CLONBURRIS T2

ARCHITECTS
FURTHER INFORMATION
RESPONSE

Planning Reg Ref: SDZ22A/0018

July 2023

Item no. 6 (b)

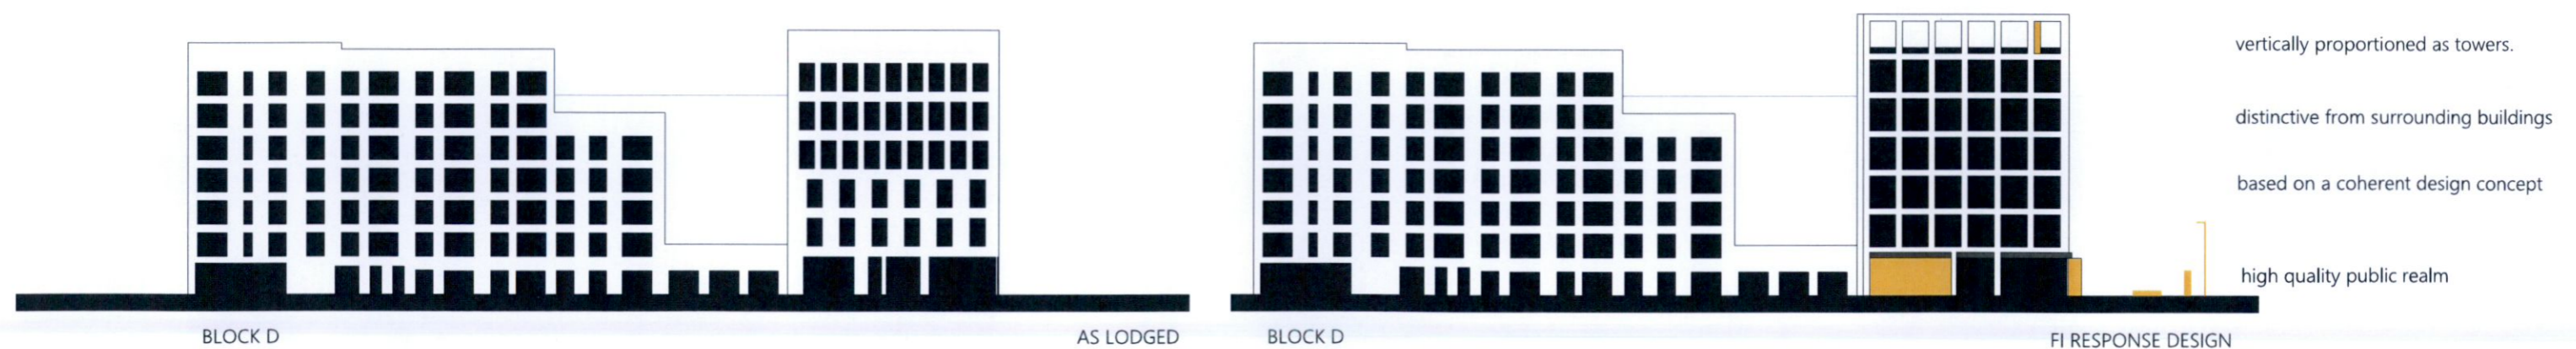
b. Landmark Buildings should be designed in a manner that is distinctive from surrounding buildings both in terms of architectural treatment and use of materials. To further emphasise their place-making function, Landmark Buildings shall incorporate high quality public realm treatment in terms of surrounding street planting, furniture, lighting and materials etc. The design of such buildings shall therefore be based on a coherent design concept that is clearly communicated via a Design Statement and Landscape Plan.

The applicant team has carefully considered the request above and a further evolution of the design approach to the Landmark Building is now proposed. The rationale is to create a stronger vertical emphasis with a clearly defined articulated frame to present a contemporary node building adjacent to the Fonthill Train Station.

The Landmark Building sits on the north-east corner of the site fronting the main railway corridor and will be visible from a distance. As such, the design approach is to create a distinct and coherent form that will act as a key marker for the urban core. The architectural language is completely different to the surrounding brick and render clad residential buildings, adding to its distinctiveness as a landmark.

To the east, north and west sides, a glazed façade sits behind a crisply detailed fibre cement frame which continues above the office levels to provide additional verticality and a visual enclosure to the roof area. The depth of the frame also provides a level of solar shading to the office floorplates. A louvred plant screen sits inboard of this to conceal the building's plant and lift motor room.

A different fenestration treatment is applied to the south elevation, with a reduction of glazing and a greater ratio of solid façade to provide a level of privacy to the residential courtyard of Blocks B & D and reduce solar gain to the office floors. At ground level, full height glazing is proposed to the office areas and the entrances are signalled by protruding curved elements clad in coloured aluminium panels.
